Access Compliance Report

Public Rights-of-Way

(Curb Ramps)

Intersection ID: 10020446	Main Street: BALTIMORE_AV	Cross Street: N/A	Location: SW
ADA ID: 56A585169884	Ramp Type: PerpDiag	Initial Pass/Fail: Fail	Overall Compliance: No
		Severity Score: 35

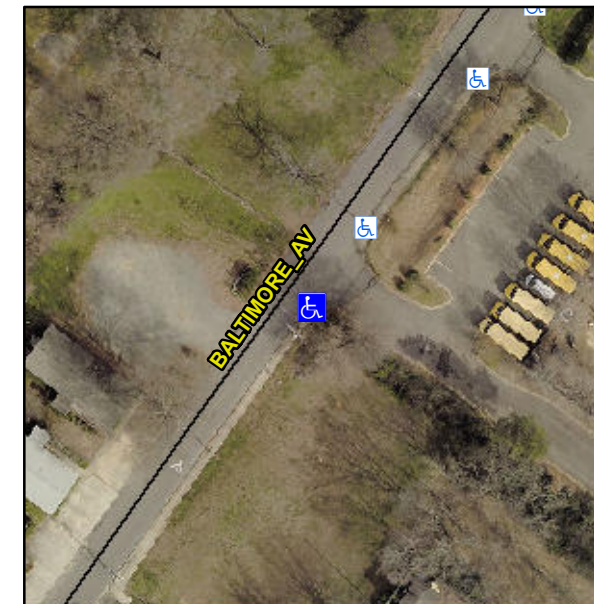
Not Found, R304.5.1, R304.2.2, R304.5.3

Compliance	Description	Data	Compliance	Description	Data
N/A	Ramp Length (in)	34.0	No	Ramp Slope (%)	13.0
No	Ramp Width (in)	37.0	No	Ramp XSlope (%)	2.6
N/A	Flare Type LT	N/A	N/A	Flare Type RT	N/A
N/A	Flare Slope LT (%)	N/A	N/A	Flare Slope RT (%)	N/A
N/A	Flare Traversable LT?	N/A	N/A	Flare Traversable RT?	N/A
N/A	Landing Length (in)	N/A	N/A	DWS Provided?	N/A
N/A	Landing Width (in)	N/A	N/A	DWS Contrast?	N/A
N/A	Landing Slope (%)	N/A	N/A	DWS Length (in)	N/A
N/A	Landing X Slope (%)	N/A	N/A	DWS Full Width?	N/A
N/A	Landing Curb? (Y/N)	N/A	N/A	DWS Offset (in)	N/A
N/A	Shared Landing?	N/A			
N/A	Gutter Ponding?	N/A	N/A	Gutter Slope (%)	N/A
N/A	Gutter Lip Ht (in)	N/A	N/A	Gutter X Slope (%)	N/A
N/A	Painted X Walk1?	No	N/A	Painted X Walk2?	No
	X Walk 1 Direction	To NE		X Walk 2 Direction	To NW
N/A	X Walk 1 Width (in)	N/A	N/A	X Walk 2 Width (in)	N/A
	X Walk 1 Slope (%)	4.0		X Walk 2 Slope (%)	2.9
	X Walk 1 X Slope (%)	8.6		X Walk 2 X Slope (%)	4.3

Remove & Replace Curb Ramp With Two New Directional Ramps or Equivalent.
